Re: **COMBINED STORMWATER MANAGEMENT  
CONCEPT/SITE DEVELOPMENT  
STORMWATER MANAGEMENT PLAN** for  
7611 FAIRFAX RD BETHESDA, MD 20814  
Administrative Subdivision 620230060  
SM File #: 288864  
Tract Size/Zone: 41,783 sf  
Total Concept Area: 33,000 sf  
Lots/Block: 23 & 24, BLOCK 4  
Parcel(s): NA  
Watershed: Lower Rock Creek

Administrative Subdivision No. 620230060  
Edgemoor

**SIGHT DISTANCE EVALUATION**

# SIGHT DISTANCE SKETCH (MNCPPC NO. 620230060)

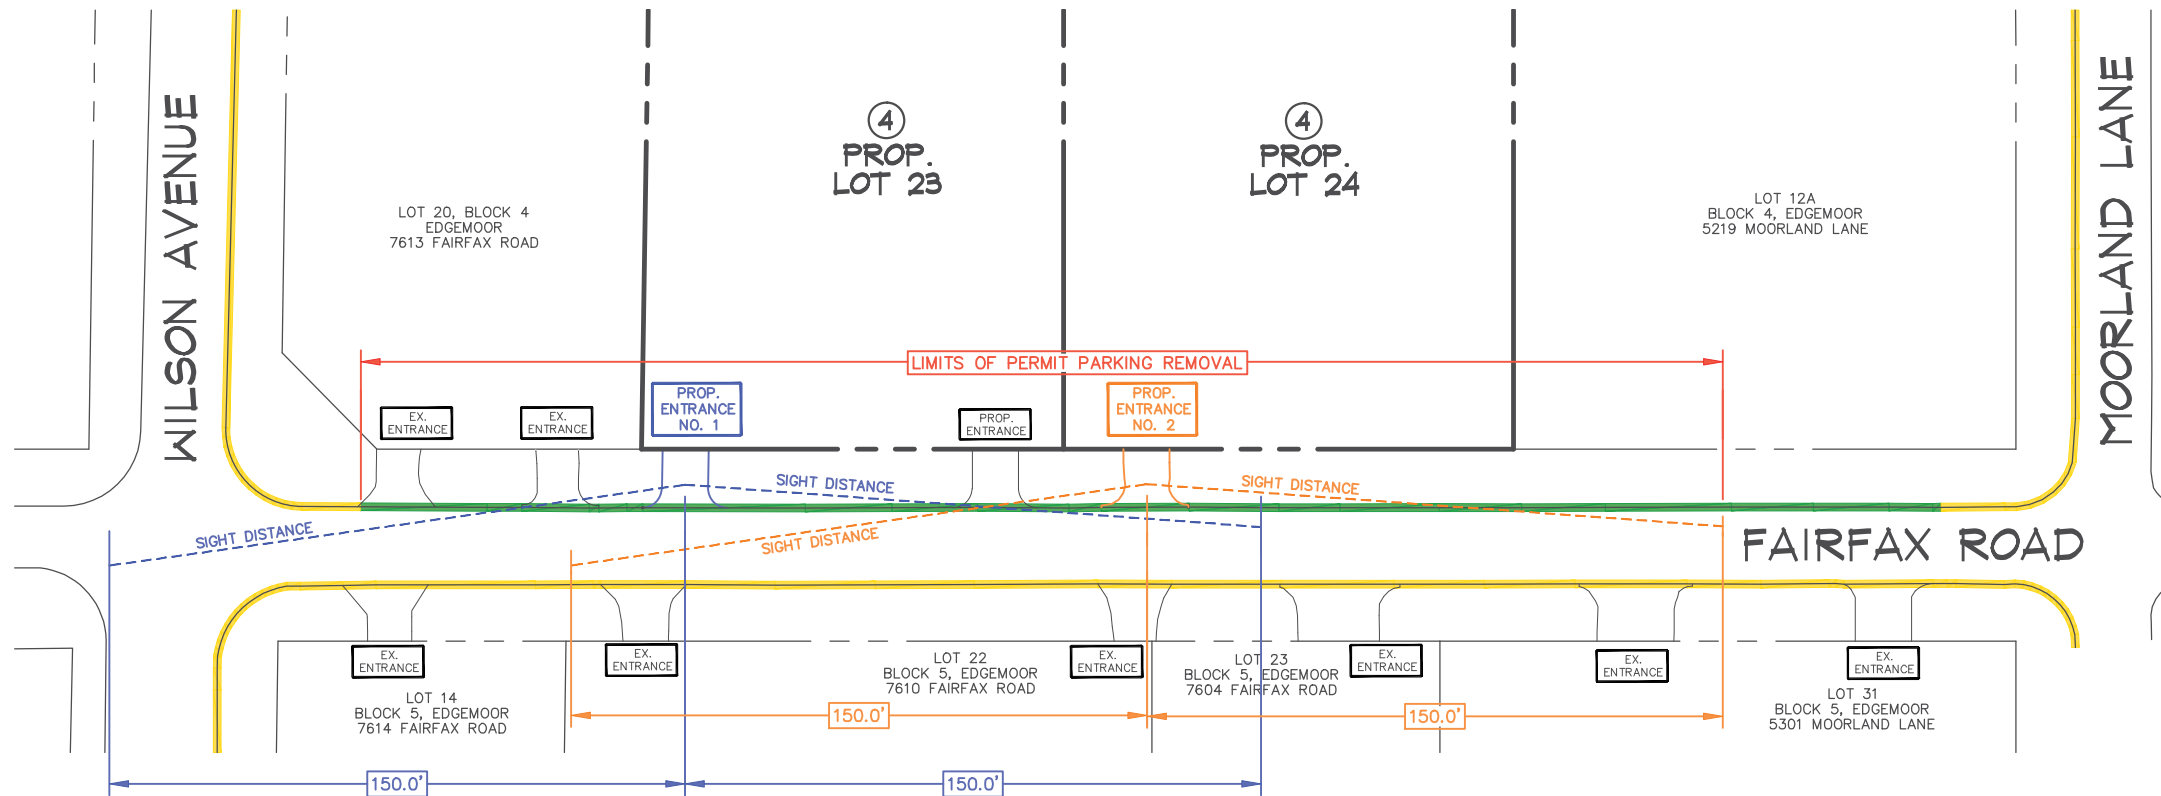
4. Sight Distance: The sight distances study has been accepted with the following condition:
  - a. Remove permit parking at the right-of-way permit stage within the line of sight to achieve the minimum sight distance as per the attached certified sight distance form with this letter.

**\*Permitted parking to be removed. See attached sketch.**
